## 产品停产通知

限位开关

发布日期  
2016年9月1日  
No. SD-L-1607003

2回路限位开关 WL-N 系列的停产通知。

内置开关的安装螺钉已变更

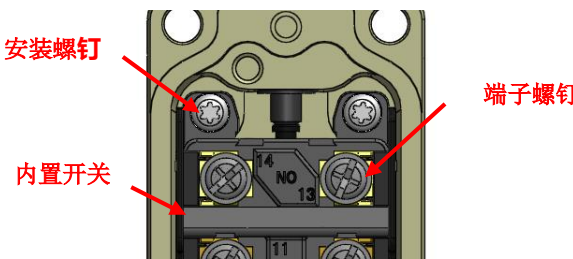
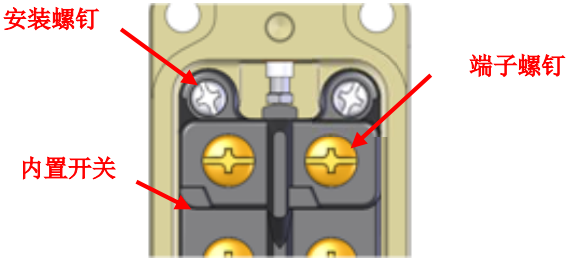
停产产品 WL-N	推荐的替代产品 WL
<p>端子螺钉: M3.5 (材质:钢带方形垫圈) 内置开关的安装螺钉: M3 (十字螺钉)</p> 	<p>端子螺钉: M4 (材质:黄铜带齿垫圈) 内置开关的安装螺钉: M3 (+-螺钉)</p>

差异点 4: 隔板变更

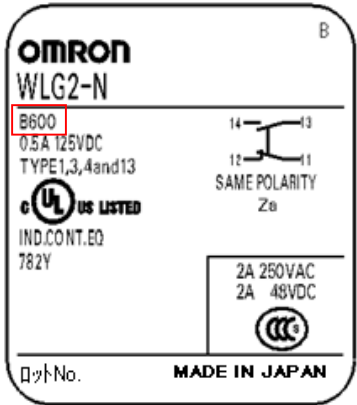
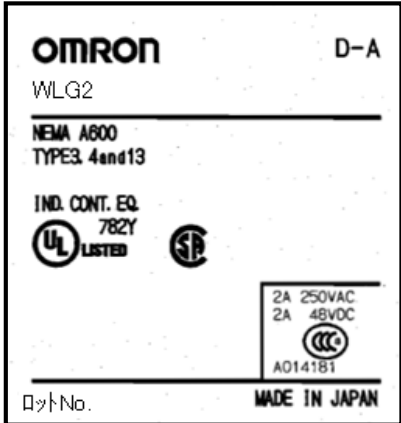
停产产品 WL-N	推荐的替代产品 WL
<p>用绝缘护罩和密封盖确保绝缘距离</p>  <p>内置开关的密封盖和绝缘护罩用于确保绝缘距离。</p>	<p>用隔板确保绝缘距离</p>

差异点 7: 型号已整合。因此动作特性已变更

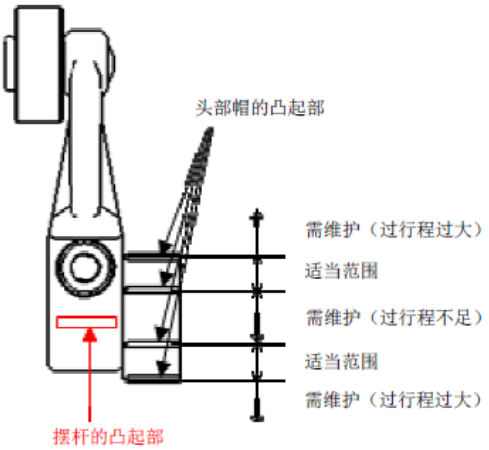
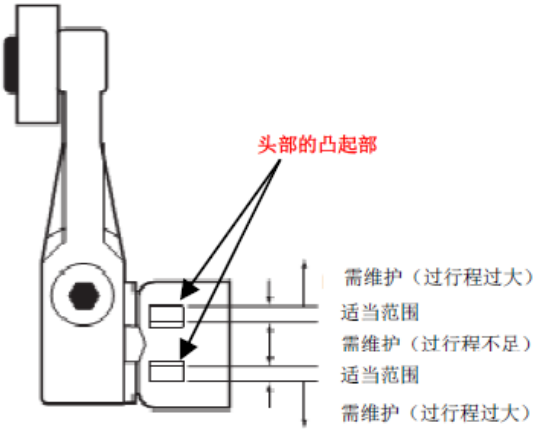
停产产品 WL-N	示例: WLG2-N, WLGCA2-N		
	项目	WLG2-N	WLGCA2-N
	动作力OF最大	13.34N	13.34N
	回复力RF最小	1.18N	1.18N
	过行程OT最小	80°	80°
推荐的替代产品 WL	示例: WLG2, WLGCA2		
	项目	WLG2	WLGCA2
	动作力OF最大	9.81N	13.34N
	回复力RF最小	0.98N	1.47N
	过行程OT最小	65°	40°

差异点 9: 电气负载的种类已整合

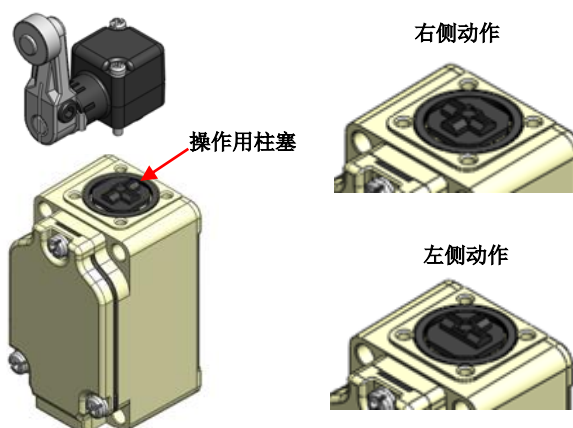
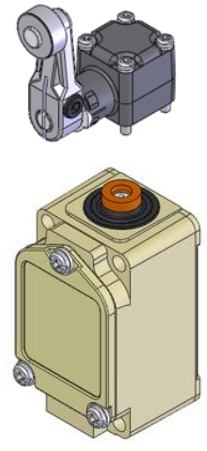
停产产品 WL-N	推荐的替代产品 WL
示例：WLG2-N（一般负载/ 微小负载）	示例：WLG2（一般负载） WL01G2（微小负载）

**差异点 13: 防腐型的产品标志已变更**

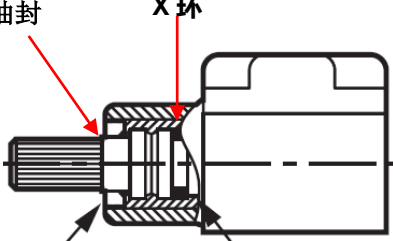
<p>停产产品 WL-N</p>	<p>推荐的替代产品 WL</p>
<p>WL*-RP-N 激光标志</p> 	<p>WL*-RP (注1) 铭板</p>

注 1: 不含密封型 (-RP40、-RP60)
